Access Compliance Report Public Rights-of-Way (Curb Ramps)

Main Street: CLYDESDALE_DR		Cross Street: BRYANT_CT		Location:	NE
ADA ID: RPRK211112120522	Ramp Type: Type 4 - Parallel	Initial Pass/Fail: Fail	Overall Compliance: No	Severity Score:	15
Codes/Mitigation Info/Possible Solution			Field Measurements/Component Compliance

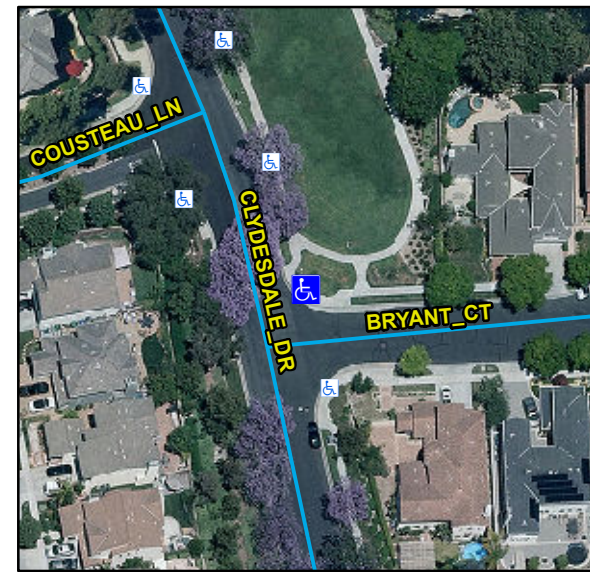
Compliance	Description	Data	Compliance	Description	Data
N/A	Ramp Length LT (in)	133	N/A	Ramp Length RT (in)	144
Yes	Ramp Width LT (in)	53	Yes	Ramp Width RT (in)	53
No	Ramp Run Slope LT (%)	8.9	Yes	Ramp Run Slope RT (%)	4.8
Yes	Ramp Cross Slope LT (%)	0.9	Yes	Ramp Cross Slope RT (%)	0.6
N/A	Landing Present	N/A	N/A	DWS Provided	N/A
N/A	Landing Length (in)	N/A	N/A	DWS Contrast	N/A
N/A	Landing Width (in)	N/A	N/A	DWS Length (in)	N/A
N/A	Landing Run Slope (%)	N/A	N/A	DWS Full Width	N/A
N/A	Landing Cross Slope (%)	N/A		DWS Offset Type	N/A
N/A	Landing Movement Obstructed?	N/A	N/A	DWS Offset Left (in)	N/A
	Landing Movement Type	N/A	N/A	DWS Offset Right (in)	N/A
N/A	Landing Shared	N/A			
N/A	Clear Space	Yes			
N/A	Clear Space To Crosswalk (in)	N/A			
N/A	Marked Crosswalk 1	No	N/A	Marked Crosswalk 2	No
	Crossing 1 Direction	W		Crossing 2 Direction	S
	Marked Crosswalk 1 Width (in)	N/A		Marked Crosswalk 2 Width (in)	N/A

Remove & Replace Curb Ramp With Two New Directional Ramps or Equivalent.

R204.3, R304.3.2, STD 1115
